Access Compliance Report Public Rights-of-Way (Curb Ramps)

Main Street: KYLE_CT Cross Street: KYLE_CT Location: SW

ADA ID: RPRK211021160508 Ramp Type: Type 4 - Parallel Initial Pass/Fail: Fail Overall Compliance: No Severity Score: 32

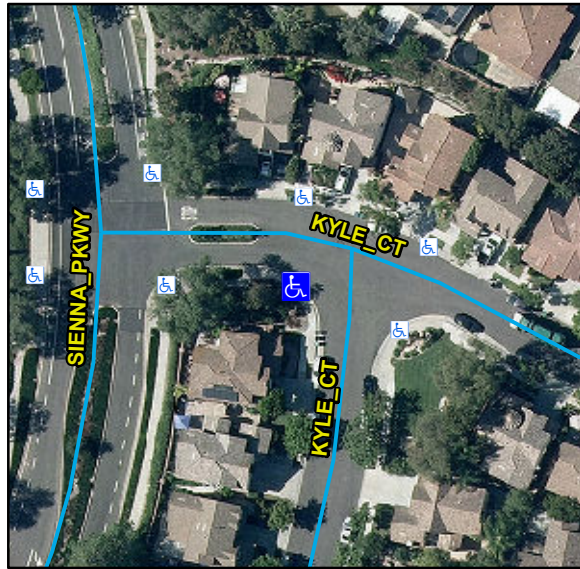
R204.3, R304.3.2, R304.5.3, STD 1115

Remove & Replace Curb Ramp With Two New Directional Ramps or Equivalent.
